MANDATORY SERVICE BULLETIN

Service Bulletin No. 612
Engineering Aspects are
FAA Approved

SUBJECT: Oil Level Gage Replacement

MODELS AFFECTED: IO-360-M Series Engines

Figure 1
Oil Level Gage and Oil Level Gage Plug Ring

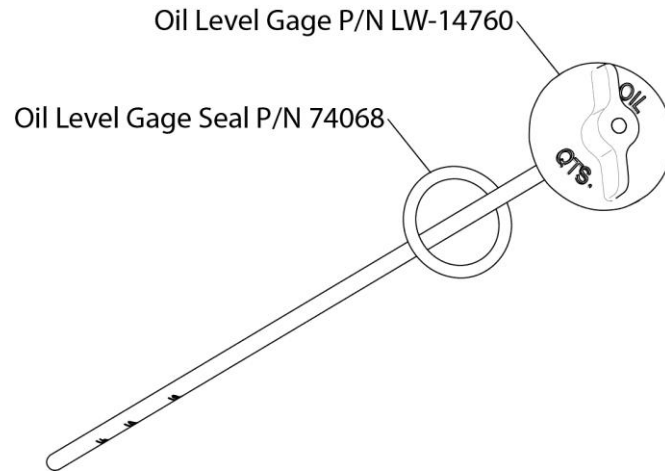
This replacement is necessary because recent validation tests show that oil level gage P/N LW-16783-18 incorrectly gives higher oil level indication when the oil level is actually less than 5 quarts (5 liters).

4. File a warranty claim through the same authorized Lycoming distributor for:
 - a. Reimbursement of the replacement oil level gage P/N LW-14760 and oil level gage seal P/N 74068.
 - b. Associated Freight.
5. Contact Lycoming Field Service at +1-570-327-7222 or 877-839-7878 if there are any questions.
6. Install oil level gage seal P/N 74068 on the new replacement oil level gage P/N LW-14760. Refer to Figure 1.

7. Install the new replacement oil level gage P/N LW-14760 with the oil level gage seal P/N 74068 on your engine.
8. Record replacement of oil level gage P/N LW-16783-18 with replacement oil level gage P/N LW-14760 in the engine logbook of affected engines.
